SAFETY RECALL P068 KEYLESS VEHICLE MODULE PROGRAMMING ISSUE-UPDATE

SERVICE BULLETIN

NO.: SA15RE-01
(issue 2)

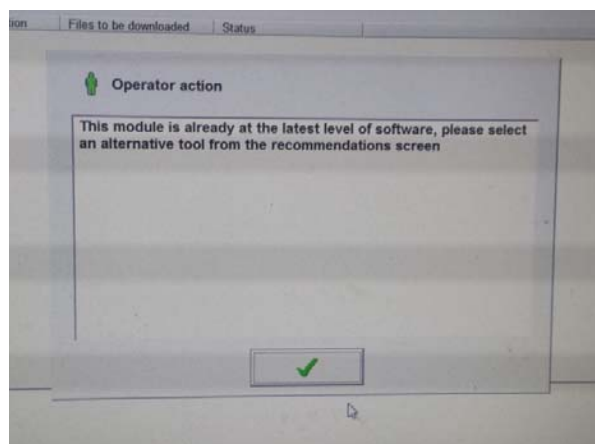
Some retailers have reported a concern where technicians, when trying to update a vehicle as part of Safety Recall P068, *Vehicle Door Will Not Latch*, are unable to update the Keyless Vehicle Module (KVM) software on Range Rover Sport and Range Rover vehicles fitted with (Gen 3) KVM hardware version 'FK72'. When this occurs, the following pop up message may appear on the SDD screen:
